**ECR #: P9**

**Title: Correction to Mounting Hole Size in Figure 3.4**

**Spec Version: NLX 1.2**

**Figure 3.4: NLX Motherboard Dimensions—11.2 inches Primary Side**

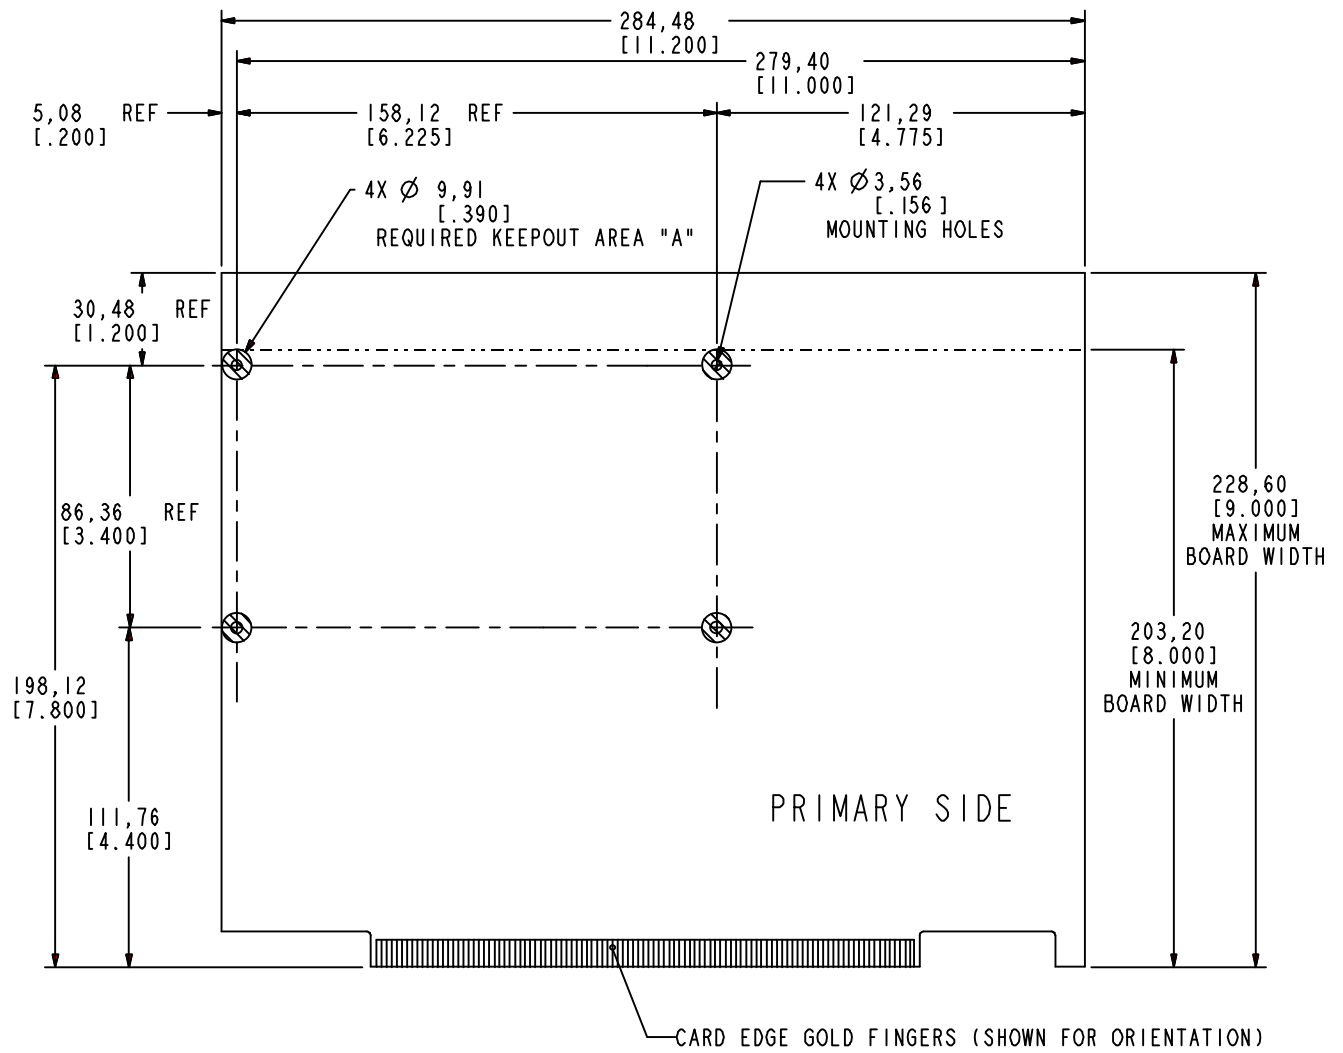
The mounting hole size in Figure 3.4 on page 16 of the NLX 1.2 specification is incorrectly called out as a 0.140" hole. It should be specified as a 0.156" hole.

An inconsistency between the mounting holes in Figures 3.2, 3.4, and 3.6 has been noted. The error occurred in Figure 3.4, which calls out the mounting hole as .140" when it should be .156".

Replace Figure 3.4 with the following figure:
